PLANNING & ZONING AGENDA ITEM #7

SUBJECT: Approval of a Preliminary Plat for Prairie Crossing Plat I

RE: Prairie Crossing Plat 1 – Preliminary Plat

RE: Prairie Crossing Plat I – Preliminary Plat

FIRE HYDRANT COVERAGE
**PRAIRIE CROSSING
 PLAT 1**
 WAUKEE, IOWA

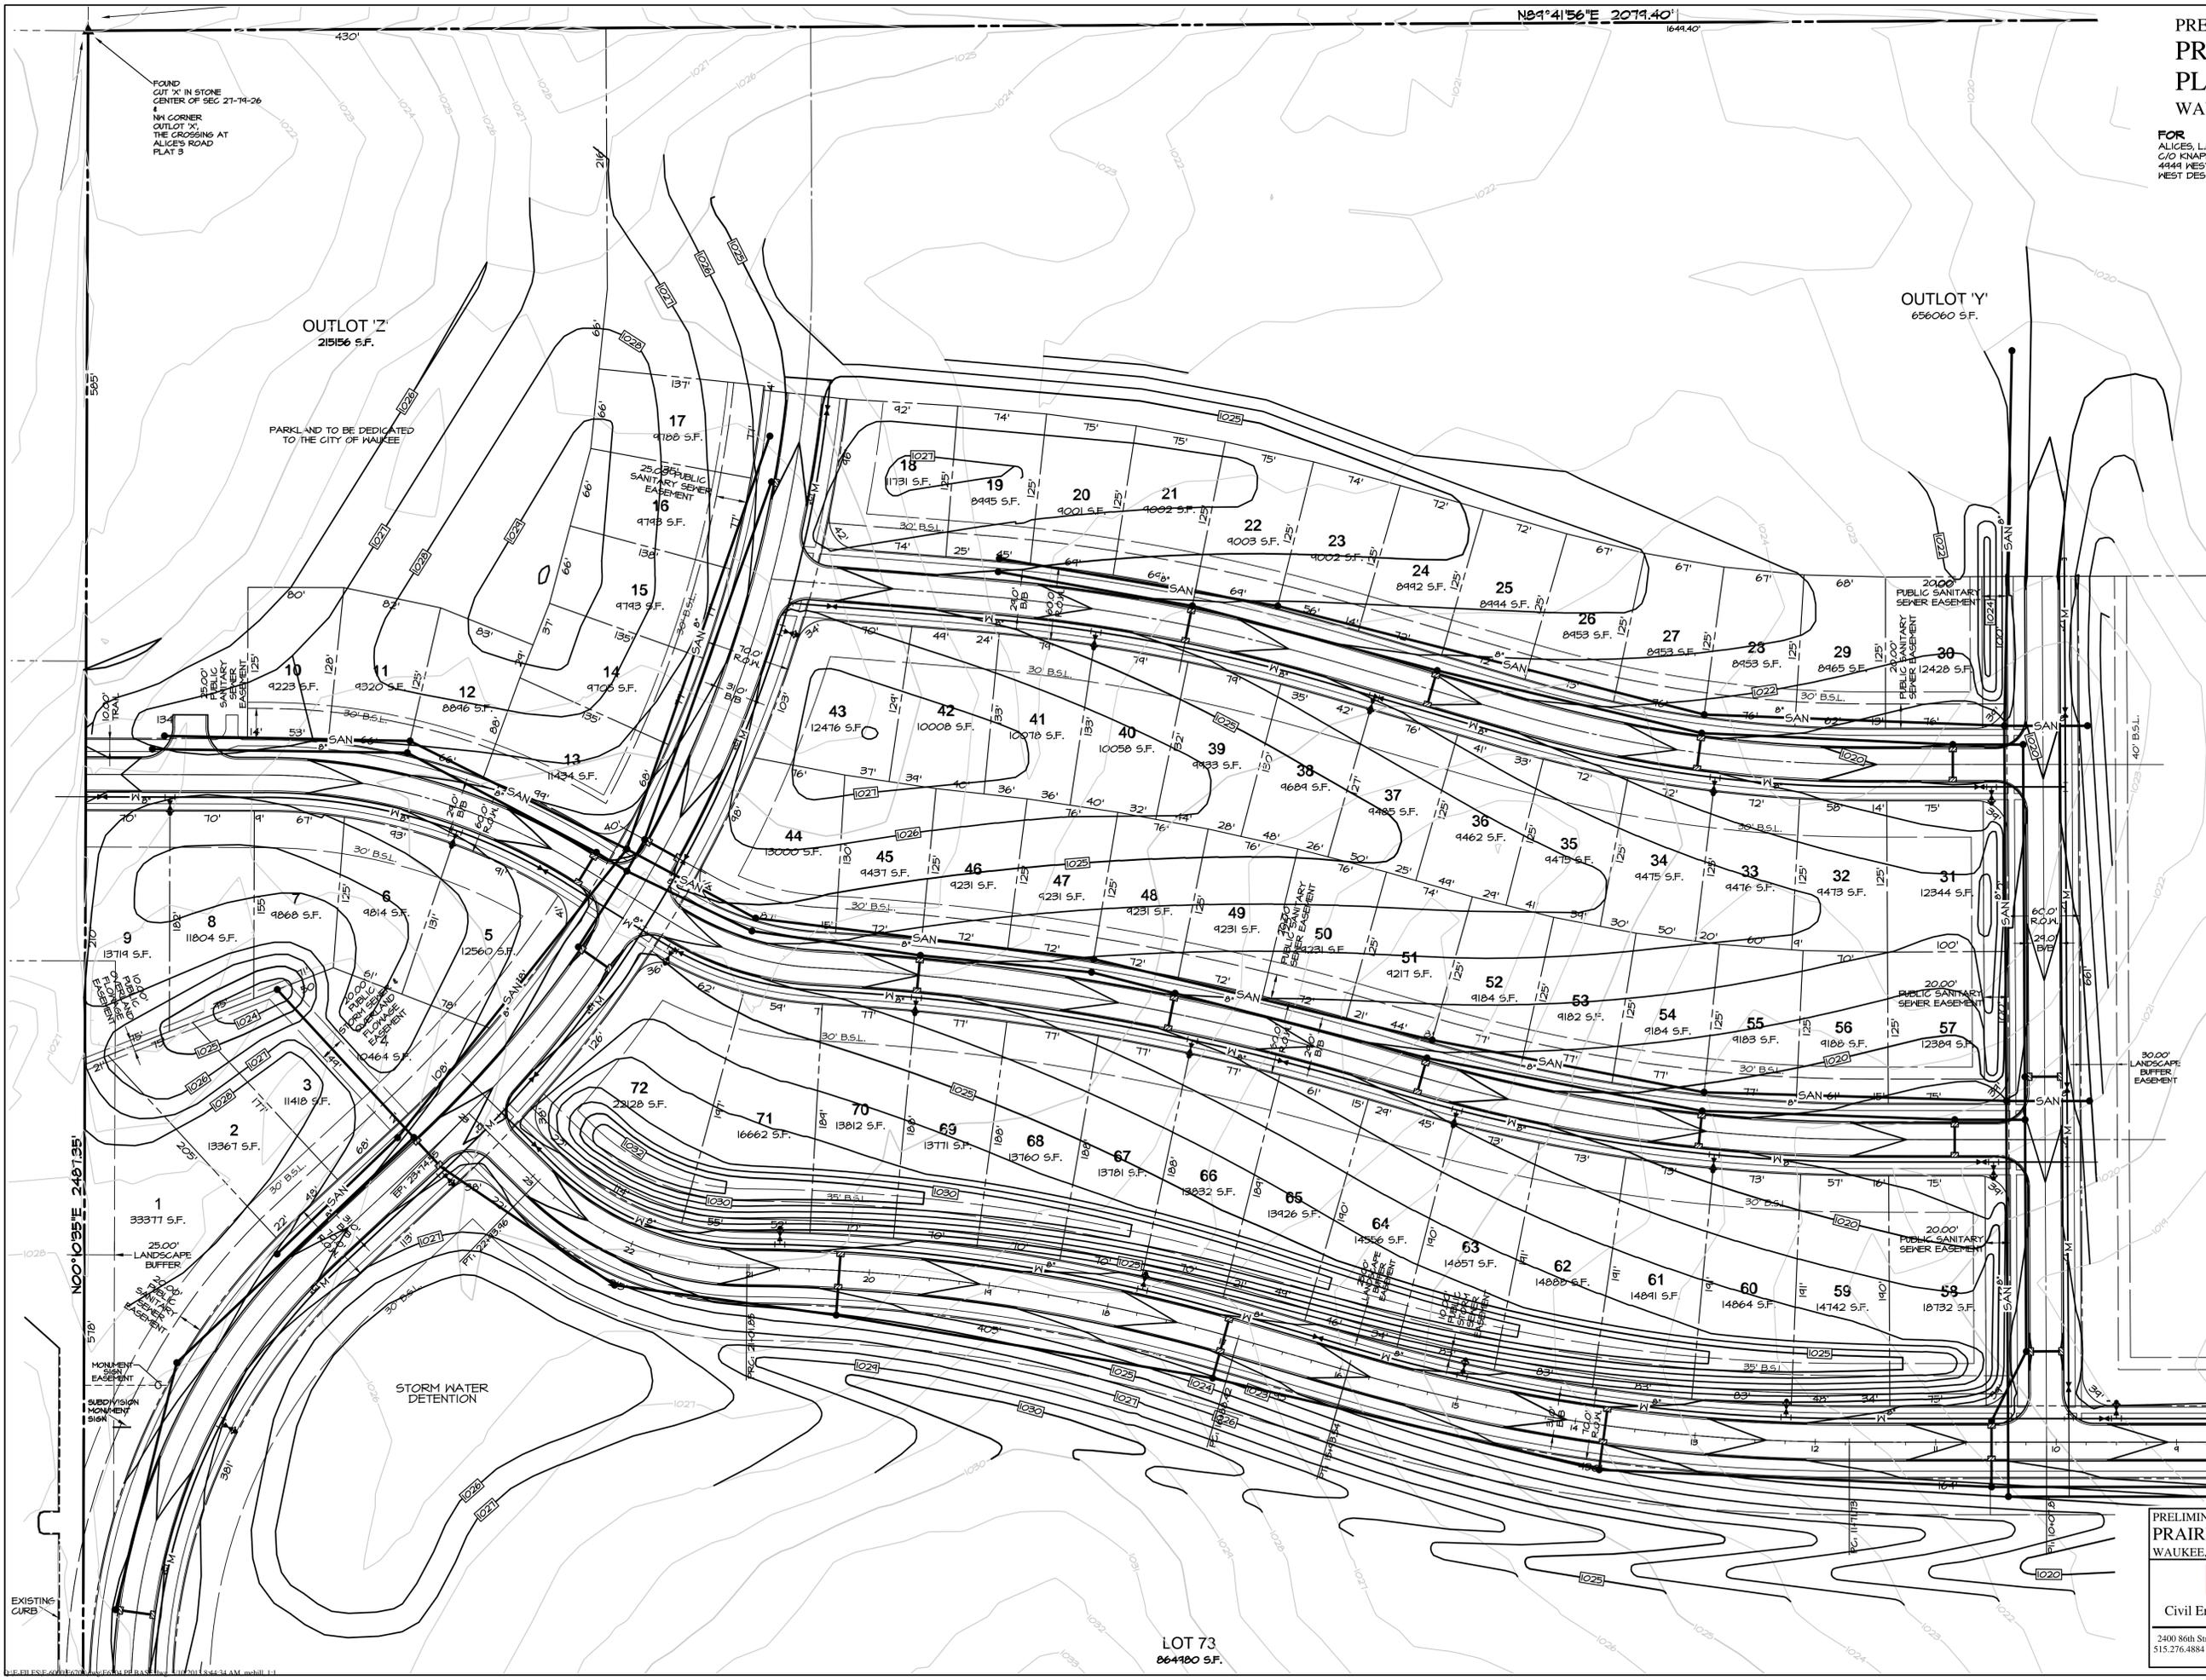
16. ~~The sidewalks within the plat are required to be 5 feet in width consistent with the current PROWAG and ADA requirements.~~
17. ~~A hydrant coverage map should be provided with the preliminary plat.~~ **Based upon the hydrant coverage map, additional hydrants should be identified as part of the preliminary plat to verify adequate coverage of all lots within the subdivision and a maximum hydrant spacing of 300 feet.**

16. ~~The sidewalks within the plat are required to be 5 feet in width consistent with the current PROWAG and ADA requirements.~~
17. ~~A hydrant coverage map should be provided with the preliminary plat. Based upon the hydrant coverage map, additional hydrants should be identified as part of the preliminary plat to verify adequate coverage of all lots within the subdivision and a maximum hydrant spacing of 300 feet. More hydrants have been added and coverage map updated~~

SHEET **3** OF 3

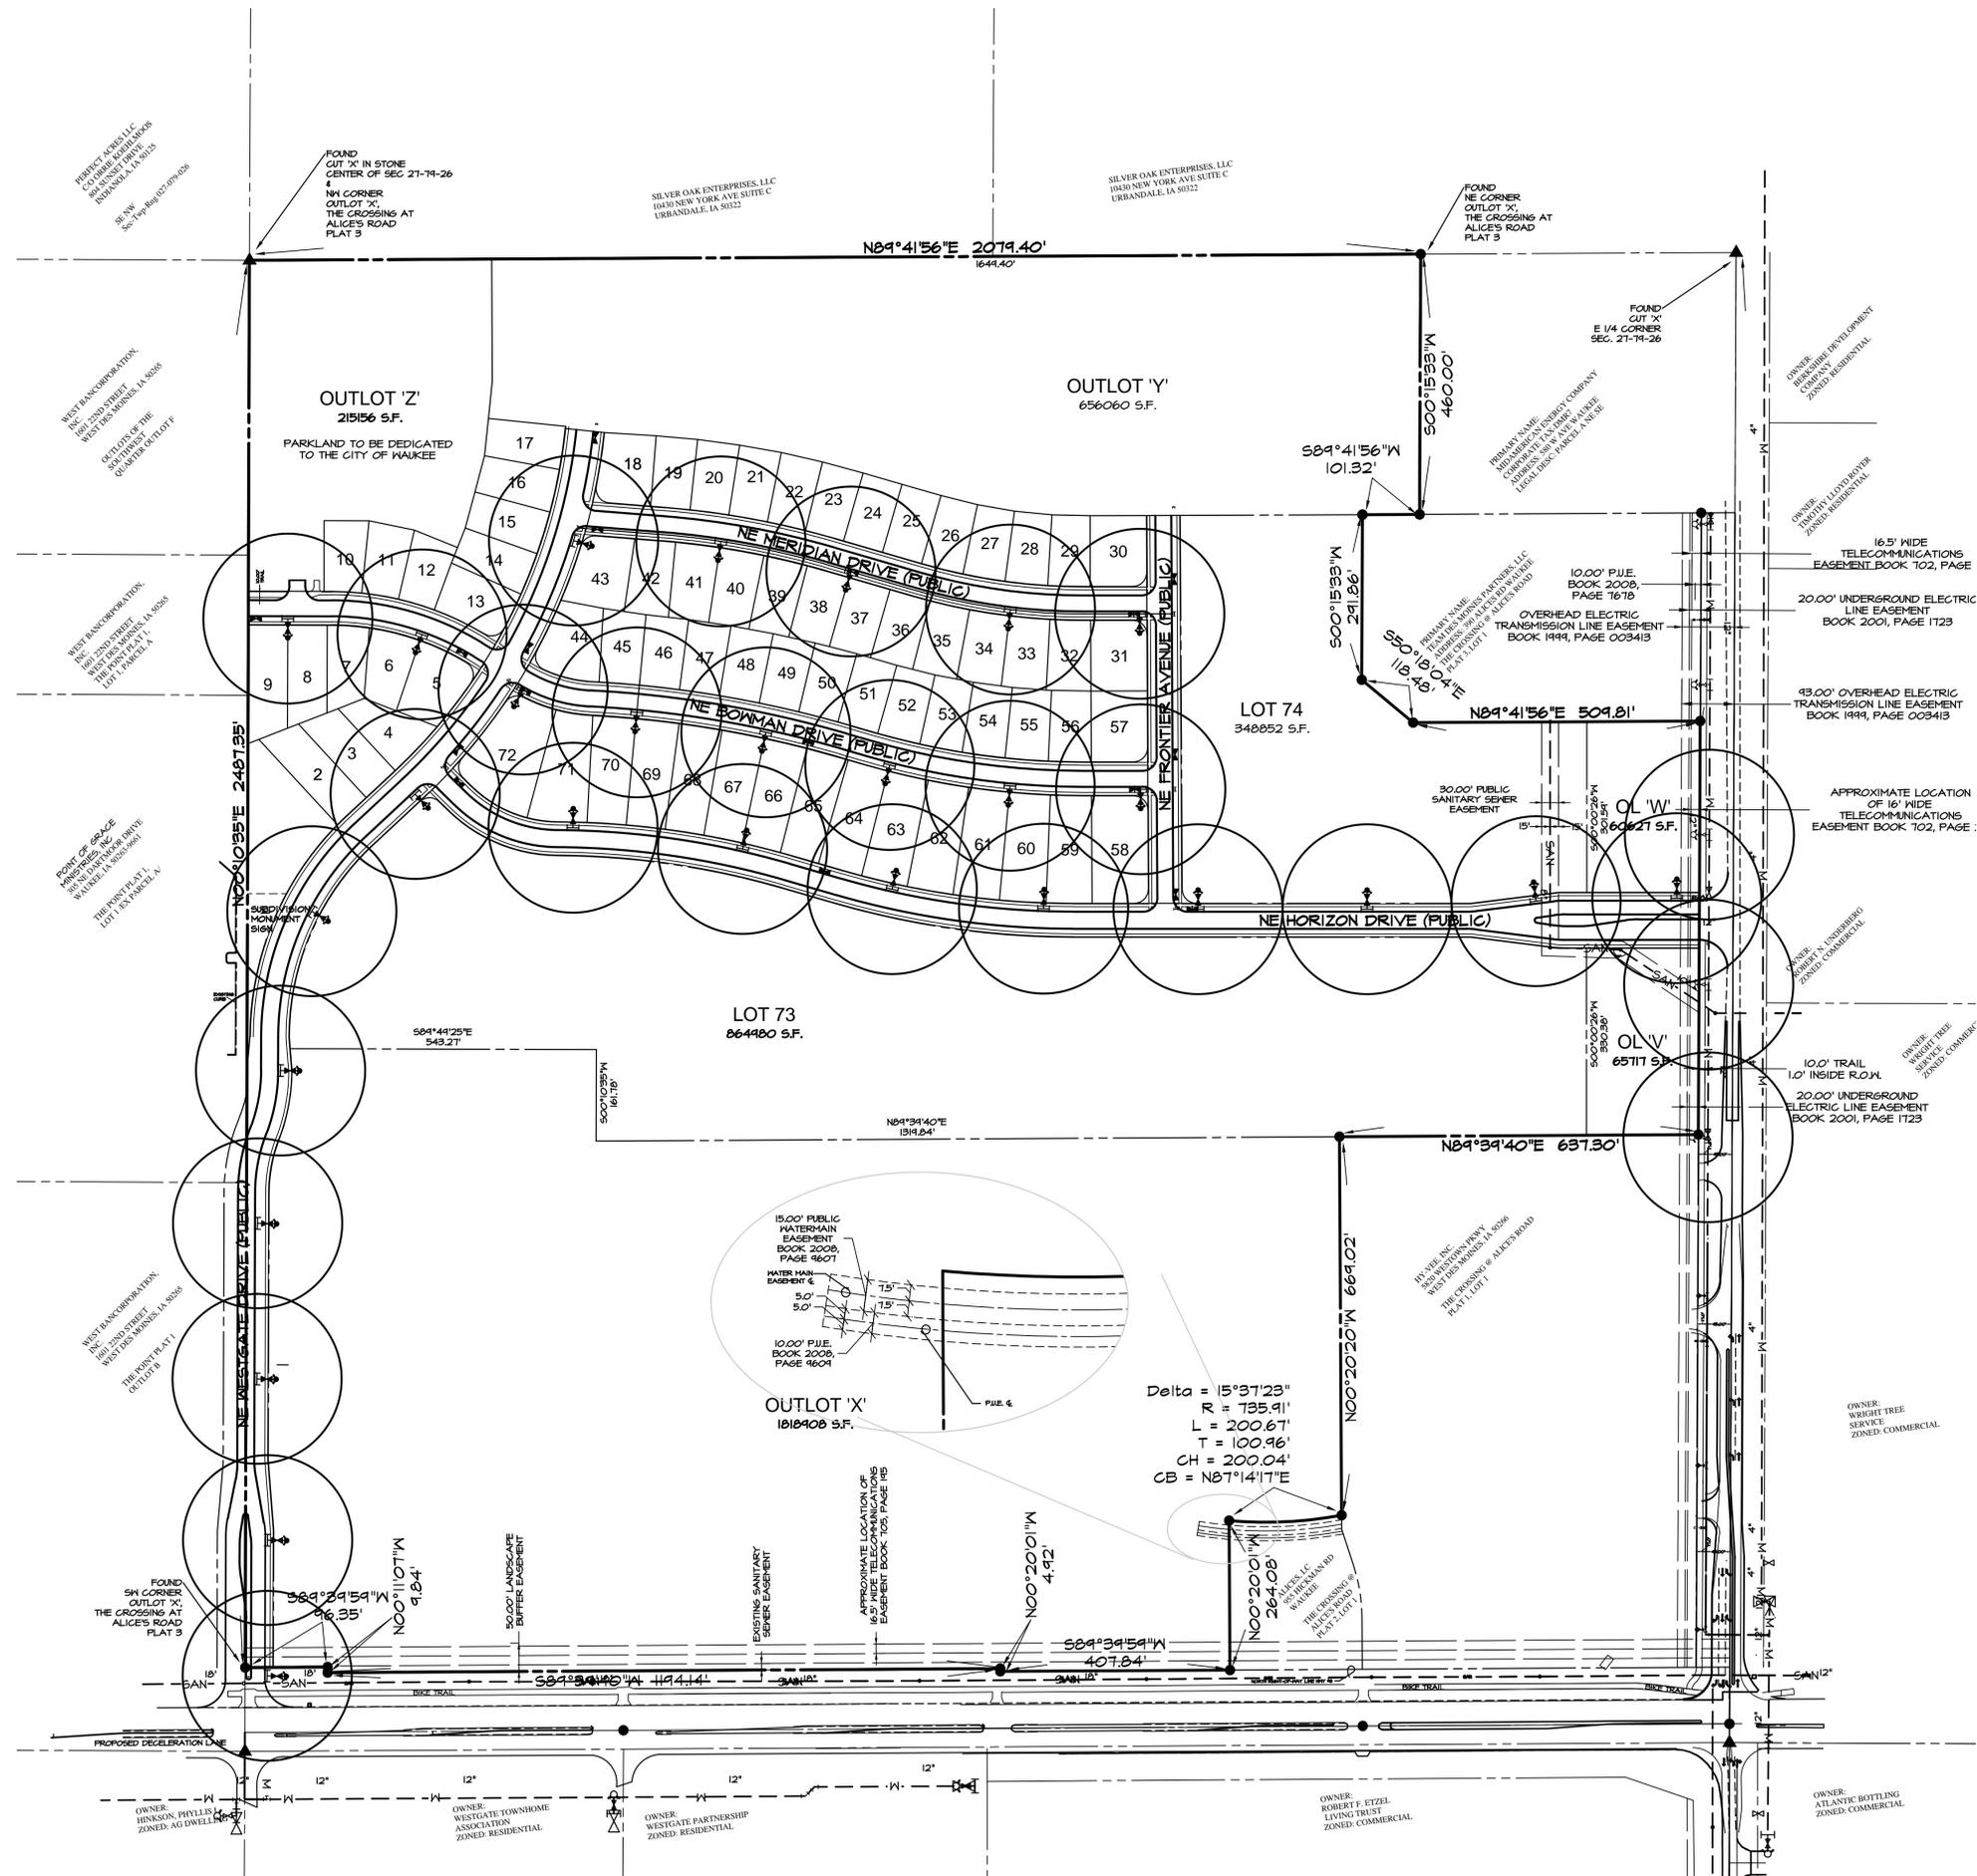
28. **The utility infrastructure extended to the Team Technologies site should be indicated on the preliminary plat on Sheet 3. Additionally, staff would prefer to have the current layout of the Team Technologies site included on Sheet 3 for reference.**

- 28. The utility infrastructure extended to the Team Technologies site should be indicated on the preliminary plat on Sheet 3. Additionally, staff would prefer to have the current layout of the Team Technologies site included on Sheet 3 for reference. This has been added.**
- 29. The full extent of paving improvement made on NE Alice's Road as part of the development of Hy-Vee should be indicated on the preliminary plat for clarity. This has been added.**
- 30. The property on the east side of NE Alice's Road, north of the Wright Tree Service property should be identified as being in the City of Clive for clarity. This has been added.**
